ADDENDUM NO. 1
TO
PROCUREMENT AND CONTRACTING REQUIREMENTS
FOR
NineStar CR200 Sewer – Division I
FOR
NINESTAR CONNECT
Issue Date: October 25th, 2023

The following, as additions to and modifications in the Bidding Requirements and Contract Documents, will be included in, and become a part of the **NineStar CR200 Sewer – Division I**. This Addendum forms a part of the Contract Documents. Bidders are, therefore, instructed to take the following into account in rendering any Bid for this work. Acknowledge receipt of this Addendum in the space provided on the Bid Form.

E209

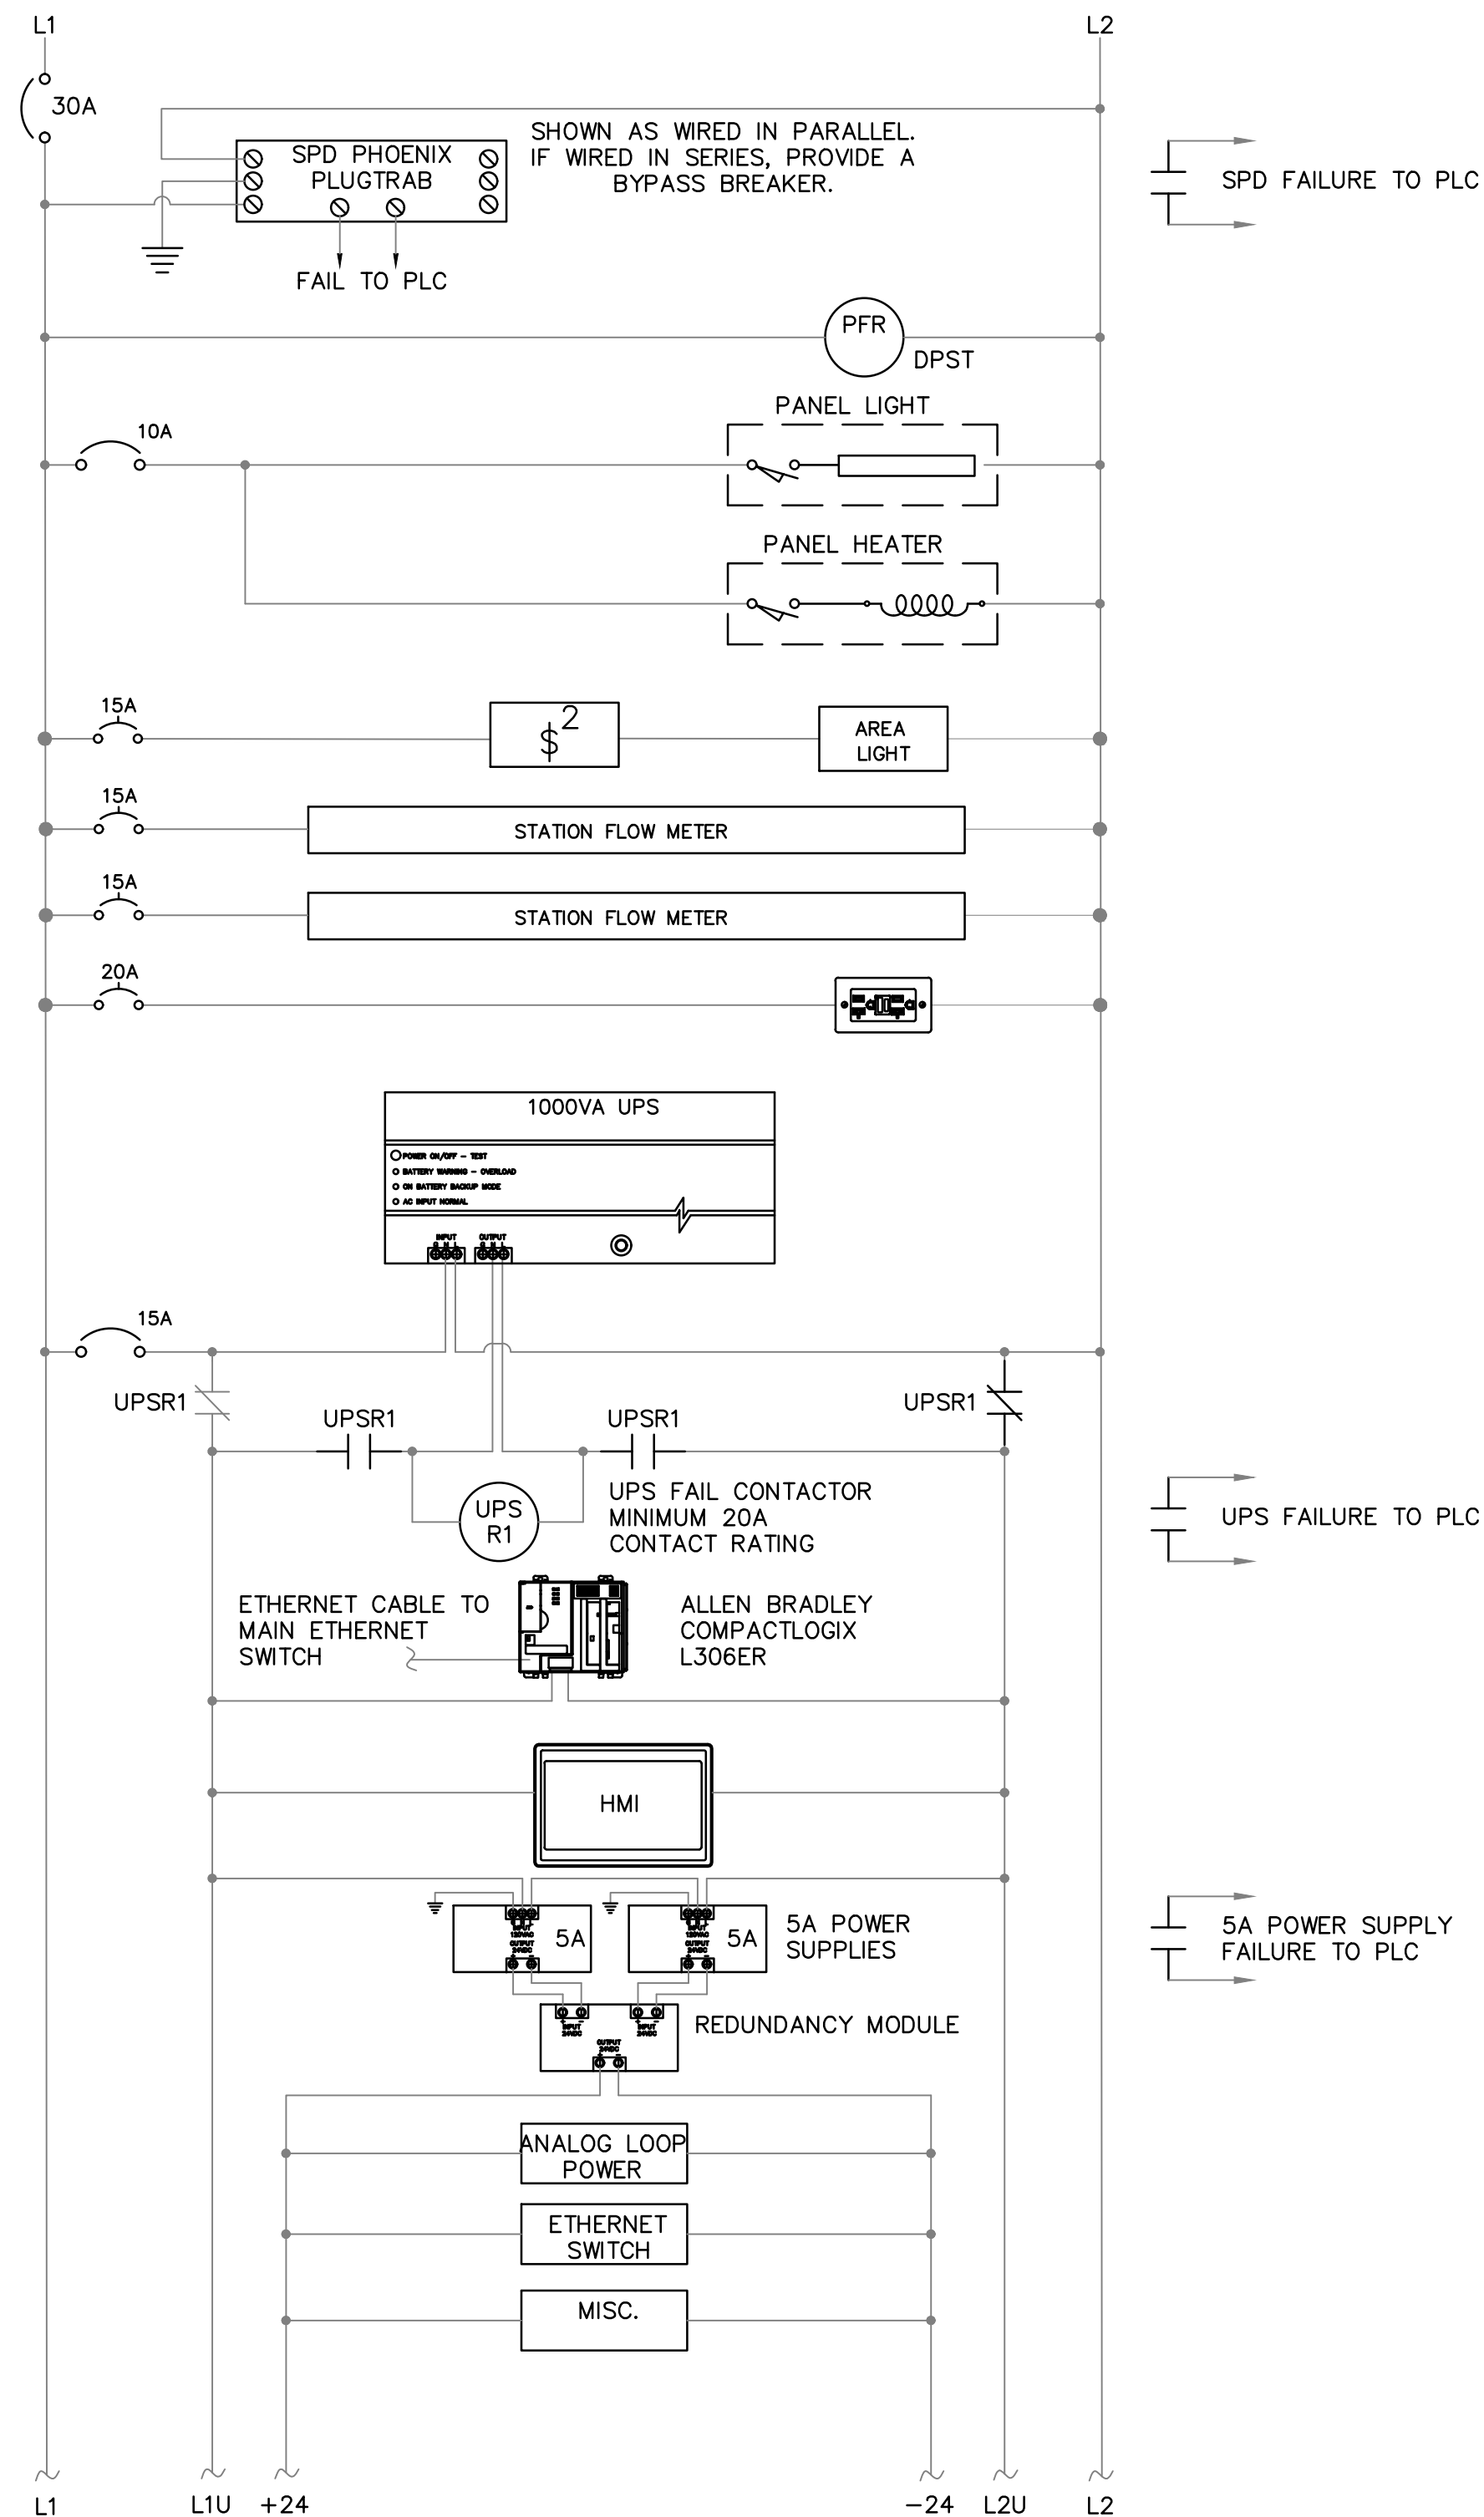
- m. Sheet E209 – Boulders PLC Control Panel Wiring Details Cont (Added generator.)
 - n. Sheet E301 – CR300 Lift Station One-Line Diagram (Updated pump electrical information.)
